**SUBJECT:** Calvert Cliffs Nuclear Power Plant  
Unit Nos. 1 & 2; Docket Nos. 50-317 & 50-318  
Request for Additional Information Regarding Measurement Uncertainty  
Recapture Power Uprate (TAC Nos. MC6210 and MC6211)

**REQUEST FOR ADDITIONAL INFORMATION REGARDING**

**MEASUREMENT UNCERTAINTY RECAPTURE POWER UPRATE**

Figure 1: Loop 12 Piping Layout Upstream of the Mitsubishi Flow Straightener with the Main Feedwater Control Valve Simulated

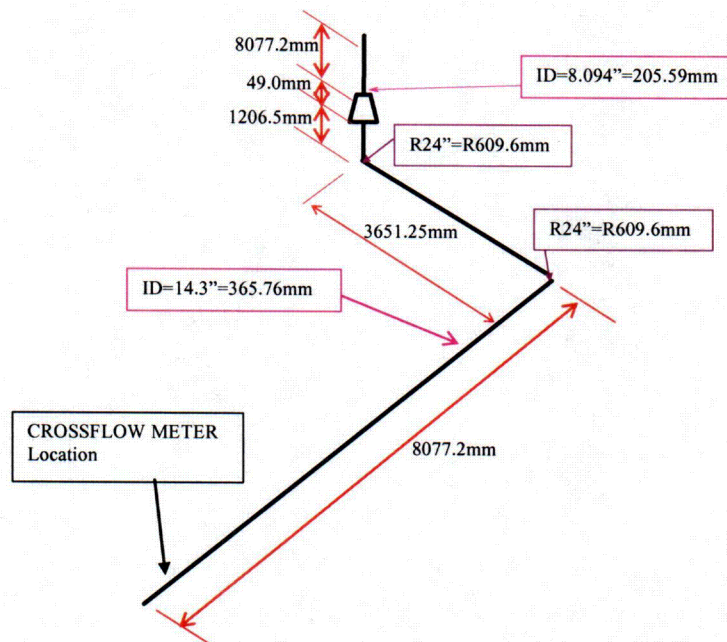
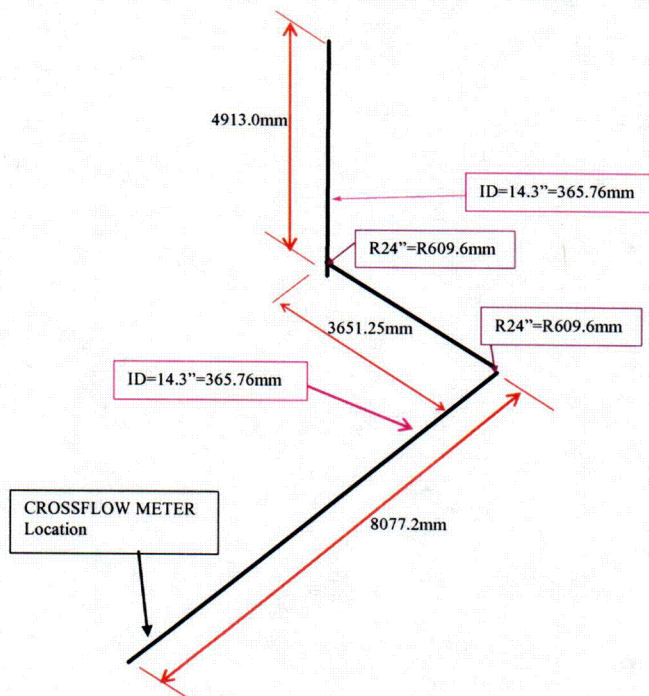
#### NRC RAI Question 1

*In Licensee Event Report 2005-003-01, dated December 15, 2005, the licensee described its actions to determine the root cause of non-conservative flow correction factors determined during chemical tracer testing for main feedwater flow.*

*Provide a summary description of the followup tracer testing and the computational fluid dynamics (CFD) analyses that have been accomplished and the findings of each analysis and test. In the case of the followup testing, provide the unrecalibrated AMAG-indicated flow rates for each of the installed instruments (Crossflow and/or X-Beam), the flow rates determined using tracer testing, and flow rates from the venturis obtained during followup testing.*

Based on the tracer test results, it was decided to perform a Computational Fluid Dynamics (CFD) analysis of the piping upstream of the Mitsubishi flow straightener on Loop 12 in order to get a qualitative picture of what was happening to the flow field in the piping system. It was decided to model the piping up to the main feedwater control valve and to simulate the control valve by using an 8 inch pipe to represent the jetting action of the feedwater exiting the cage of the valve into the approximately 14 inch (inner diameter) feedwater pipe. For control purposes, a second model was also developed with the same piping configuration, but without the 8 inch control valve pipe simulation.

Figures 1 and 2 show the two CFD piping configurations with and without the 8 inch pipe. Figures 3 and 4 show the differences in swirl that are generated in the pipe due to the jetting action of the control valve and Figures 5 and 6 show the velocity profiles at the location in the feedwater pipe where the CROSSFLOW meter is located.
